PROJECT:
Kenyon Lane - Block 3 - Plots 8 & 9

DESCRIPTION:
Block 3 - Proposed Plans

FILE IDENTIFIER:
KL-BTP-03-ZZ-DR-A-3785_155.E

House Type 2b - Ground Floor Plan
1 : 50

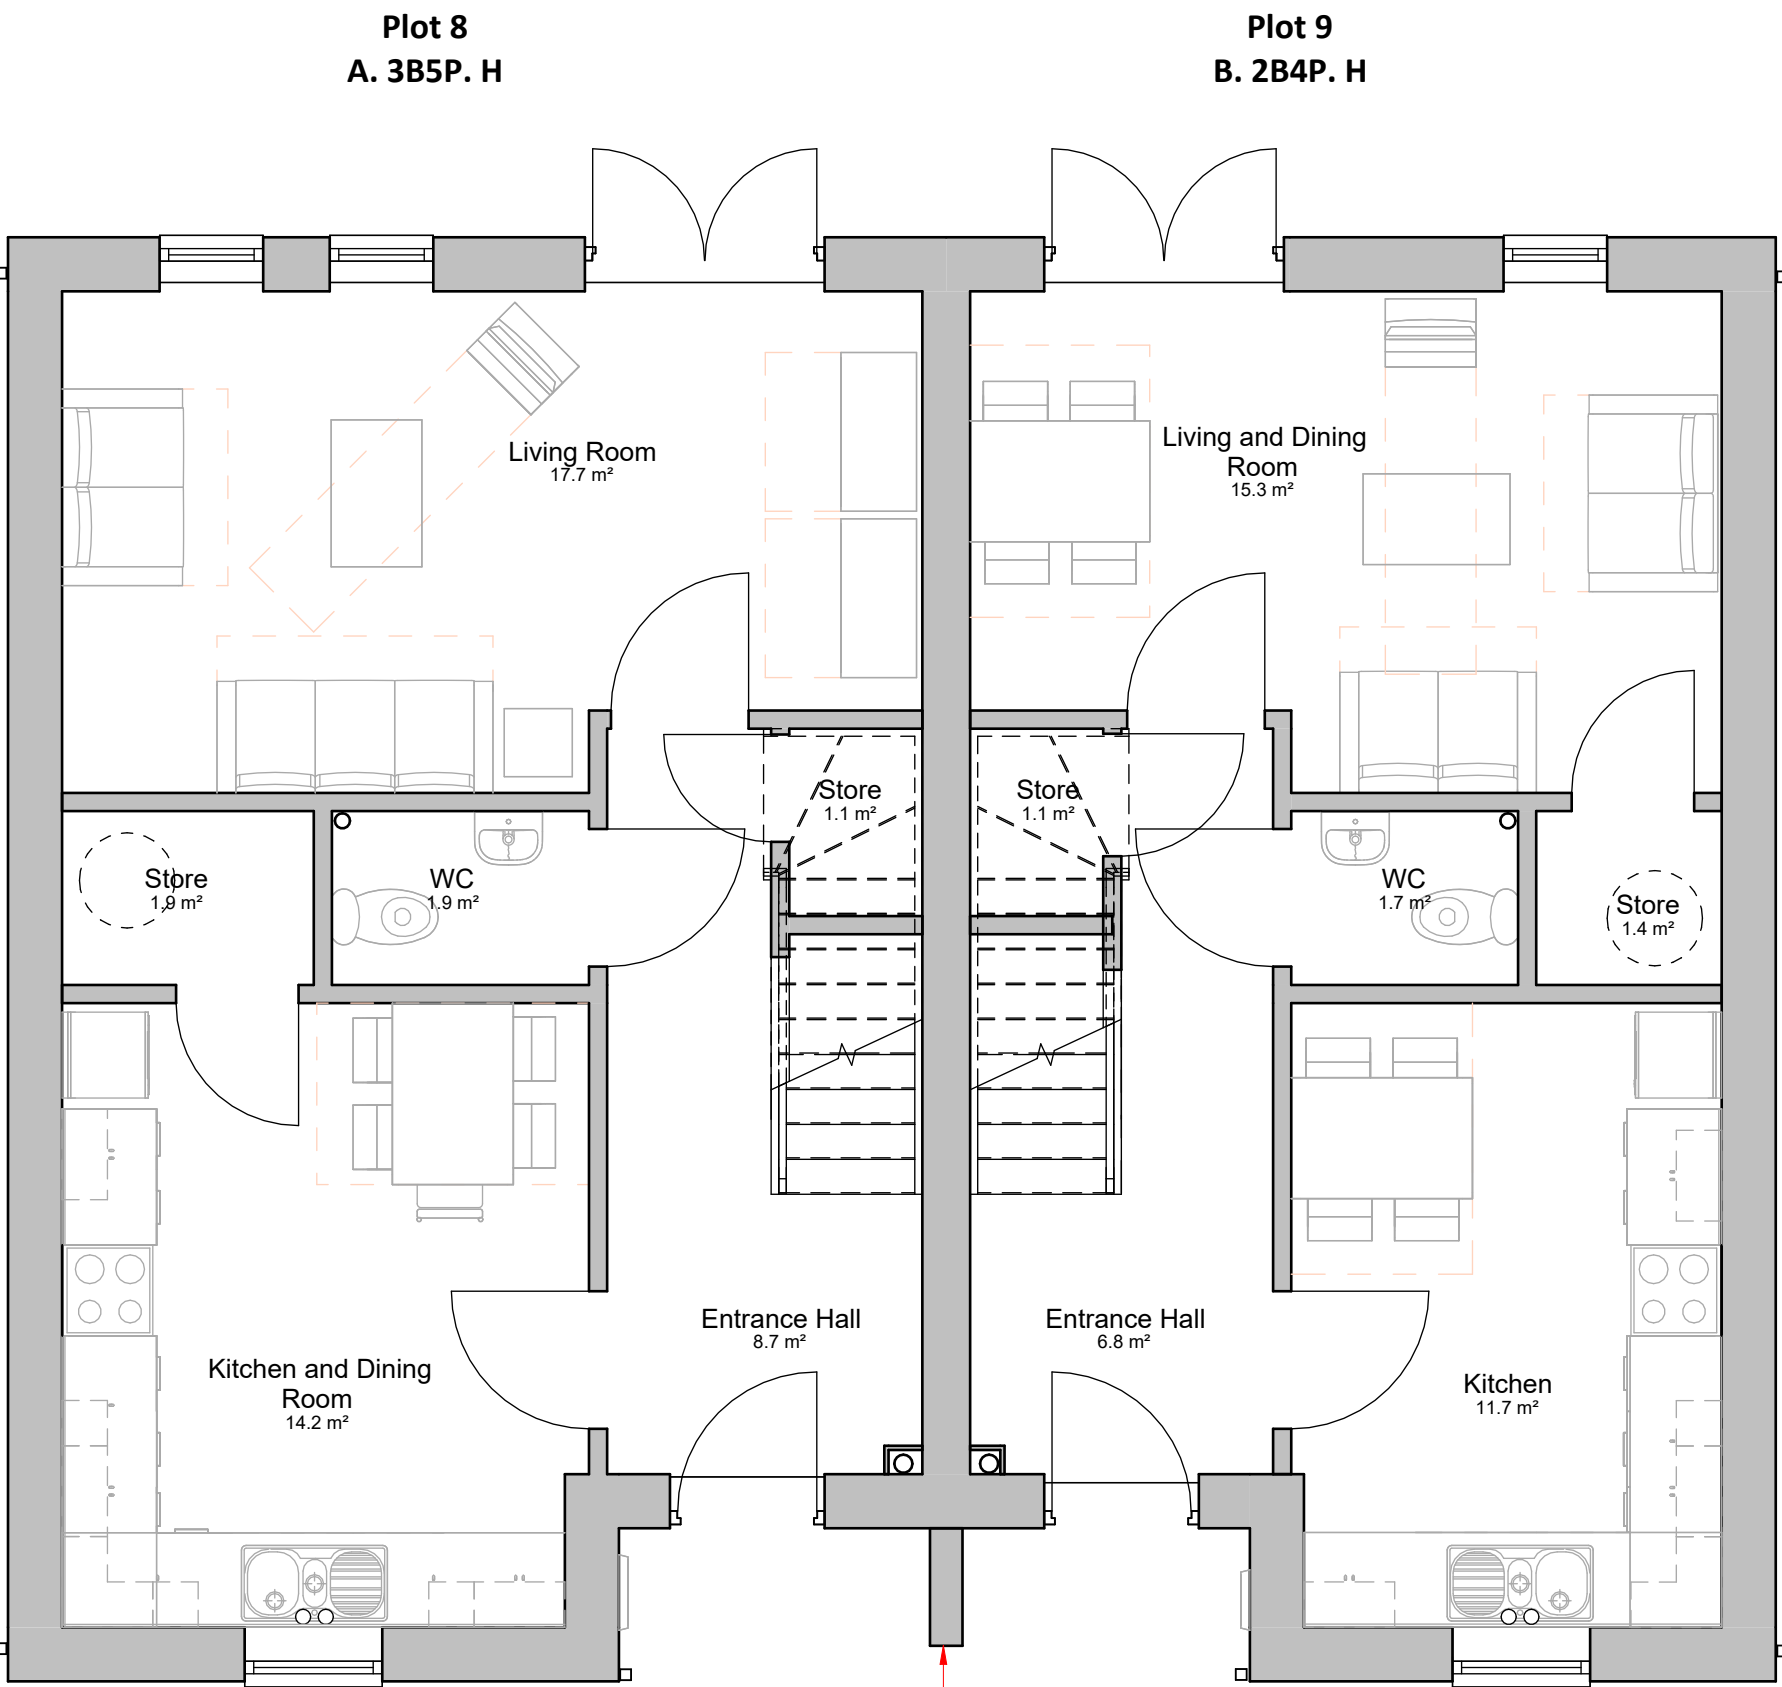
All brick returns and timber trellis' removed to front entrance of units
*Internal layouts updated to accommodate cylinder store.
1no. meter box to front of each unit removed in accordance with proposed installation of ASHP and cylinder system

House Type 2b - Roof Plan
1 : 50

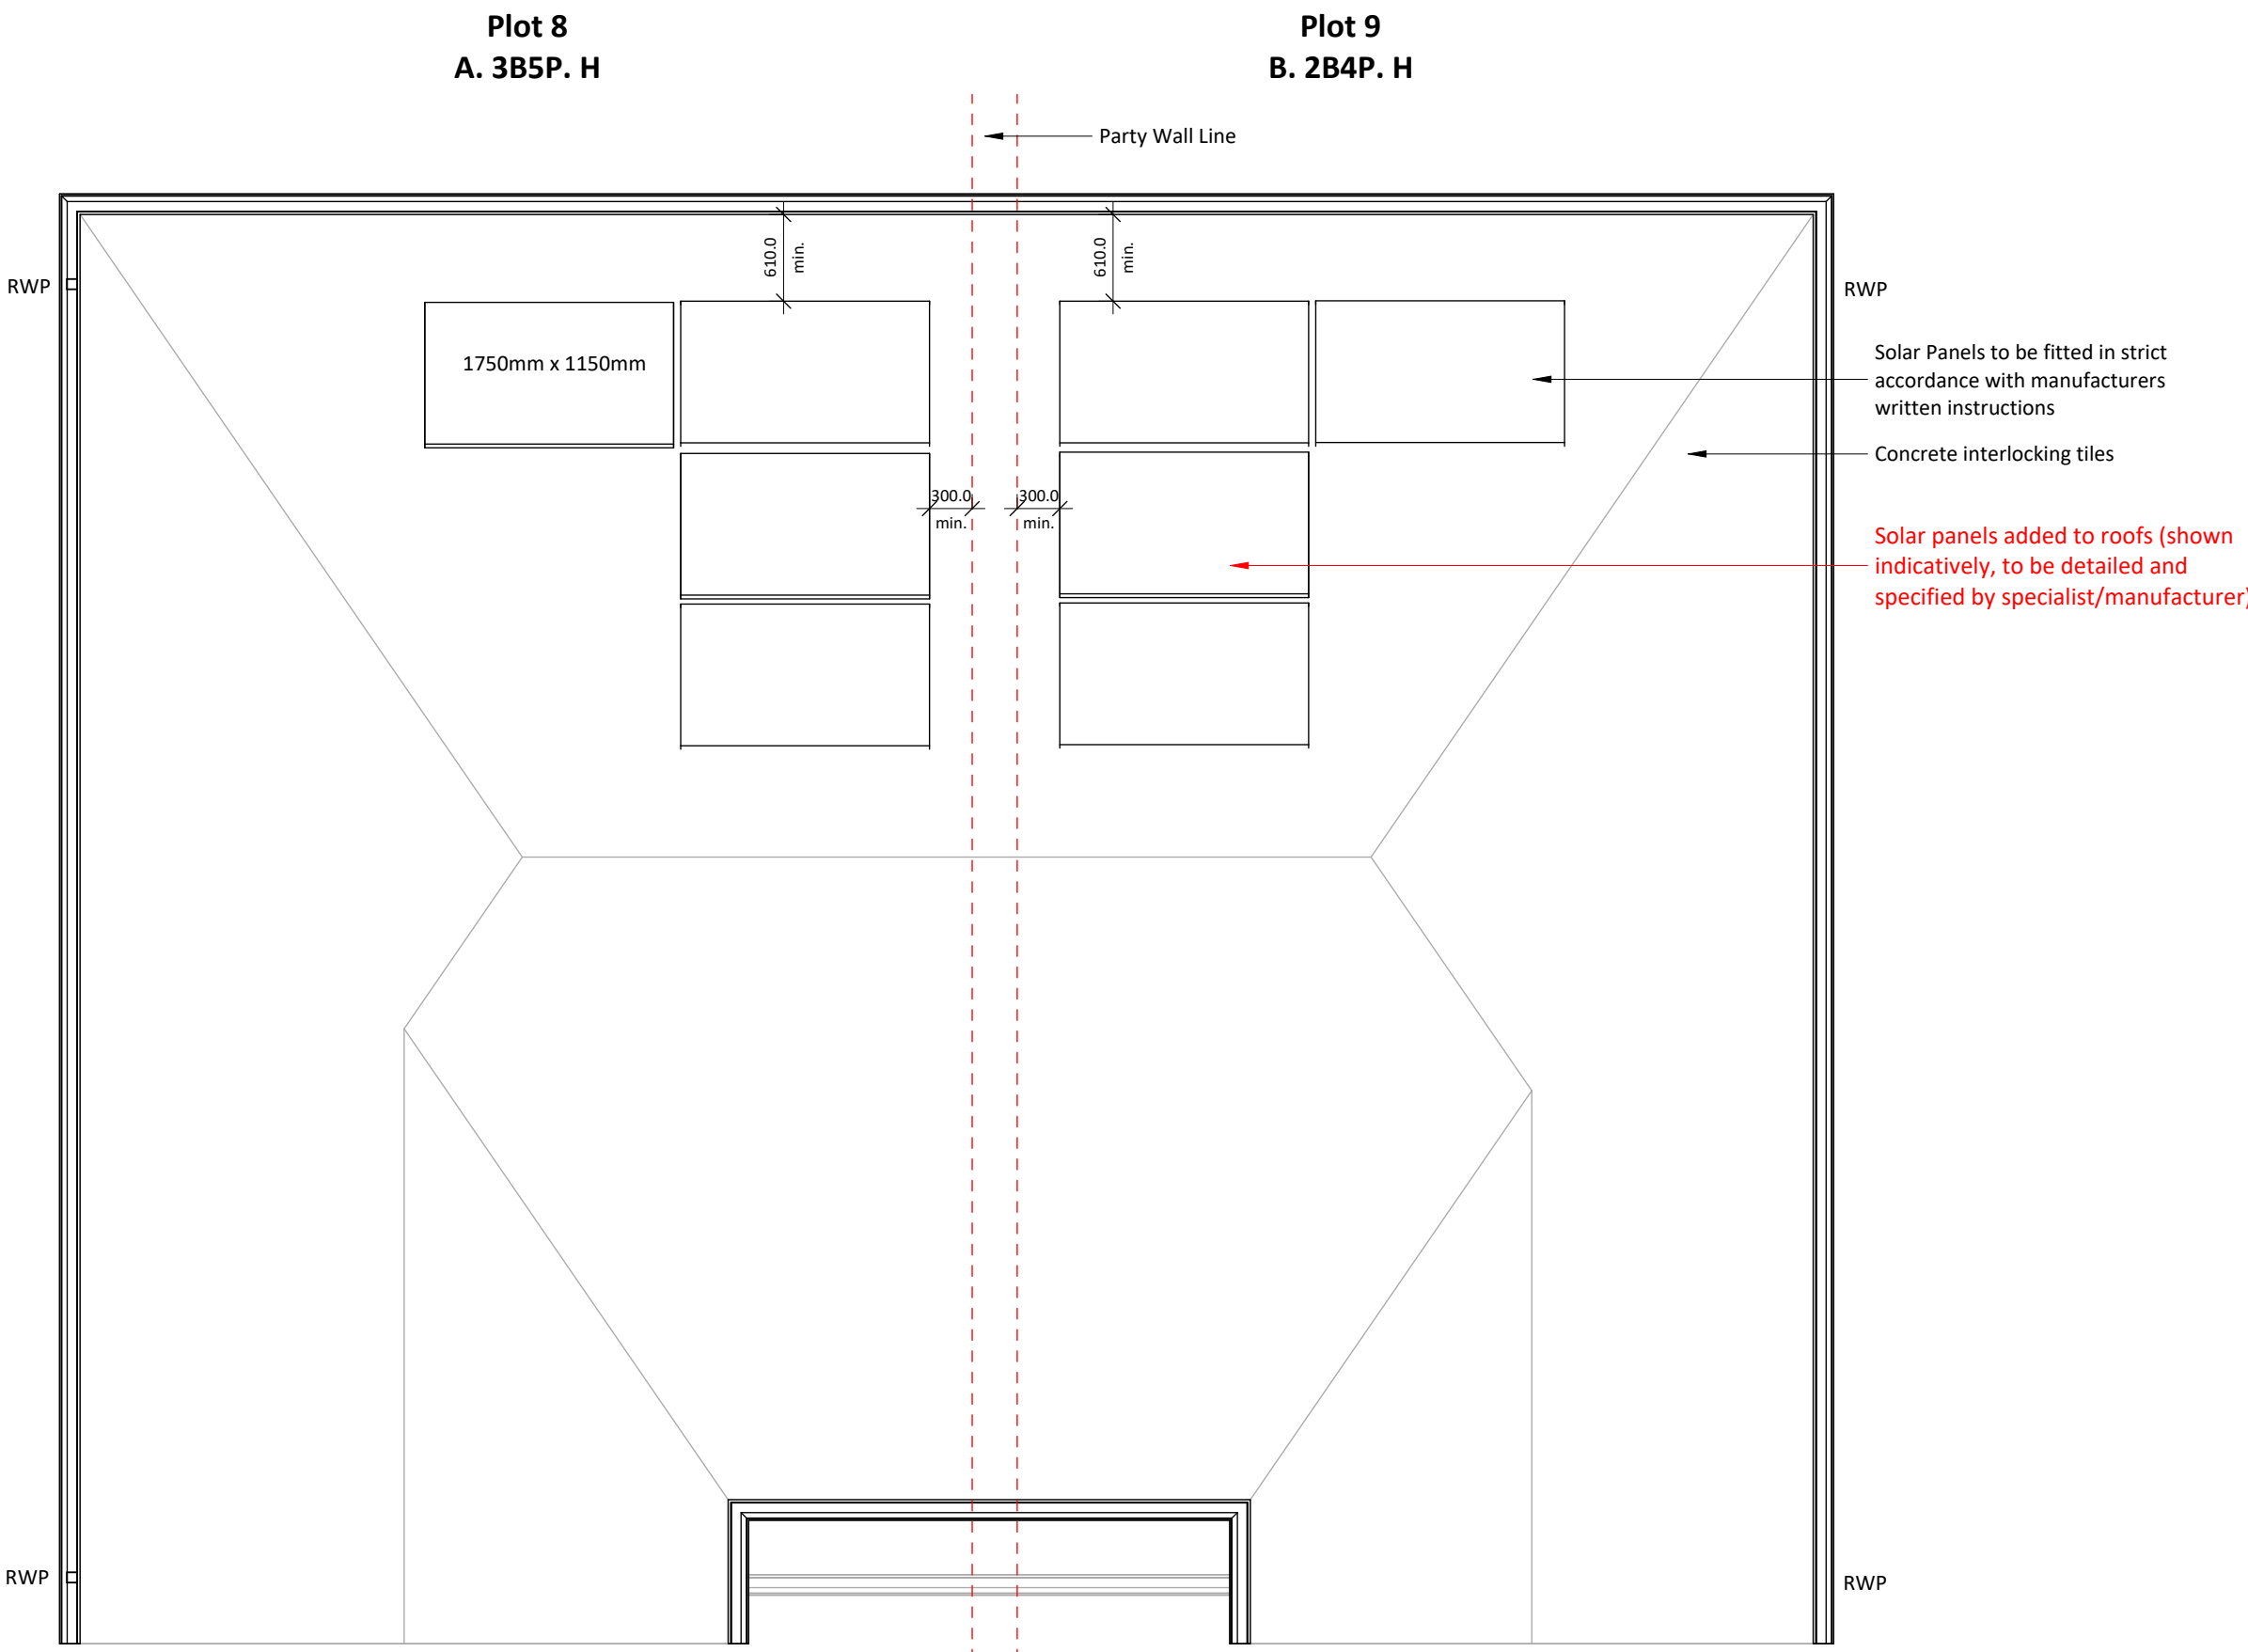
Depth of all entrance canopies reduced to accomodate rainwater drainage
